These documents were provided to the Planning and Zoning Board/Local Planning Agency by Mrs. Marla Molina for Public Hearing Agenda Item “400” at the October 2, 2019 Planning and Zoning Board/Local Planning Agency Regular Meeting.

RE: Northern Oaks - plan review  
CPH project W04183

# FINAL SUBDIVISION PLAN FOR NORTHERN OAKS SUBDIVISION CITY OF WINTER SPRINGS, FLORIDA

**DRAINAGE PLAN**  
 NORTHERN OAKS SUBDIVISION  
 CITY OF WINTER SPRINGS, FLORIDA

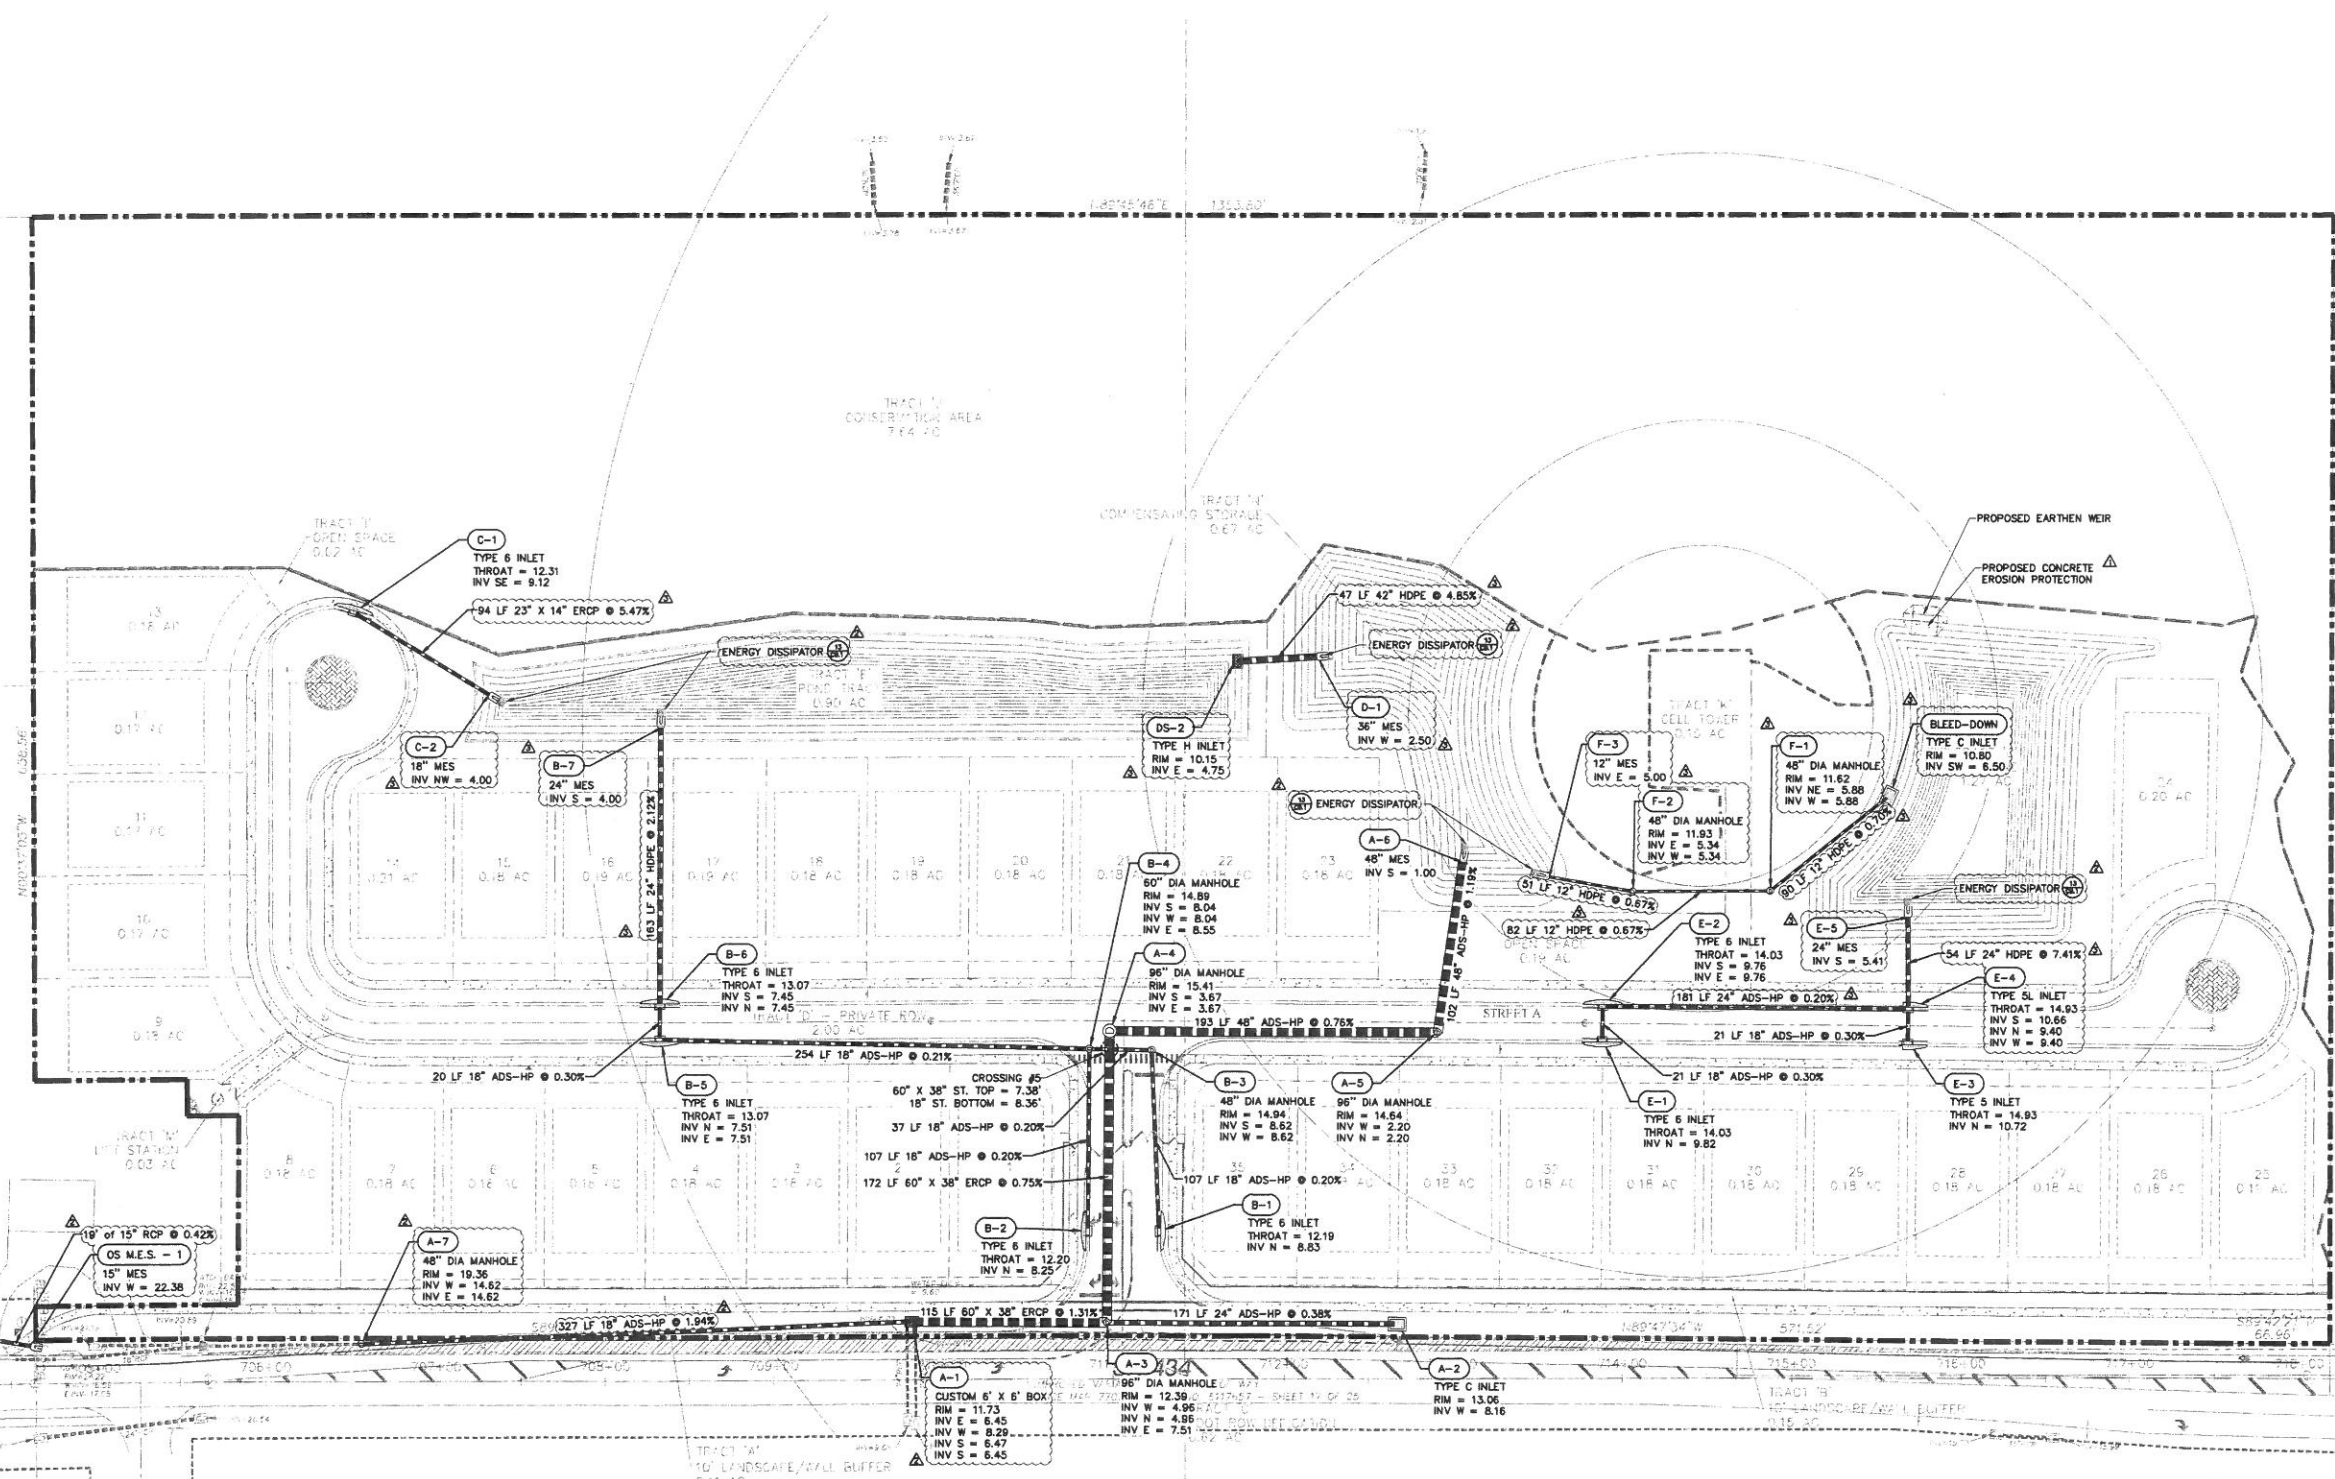
We reviewed the permitted plans and storm water calculations we retrieved from the St. Johns River Water Management District (SJRWMD) to verify if the total impervious area per lot can be increased from 40% to 50%, maximum.

The calculations for the two wet ponds indicate there is more volume than required for the original design. We were able to verify the total impervious area for each lot and recalculated based on an additional 10% impervious area for each lot to determine a new total impervious area.

Based on our calculations, the ponds, as designed and permitted through the SJRWMD have sufficient capacity to allow the developer to increase the impervious area on each lot to 50% coverage.

We do not have any objections to the City approving the additional area for each lot, to a maximum of 50% for each lot.
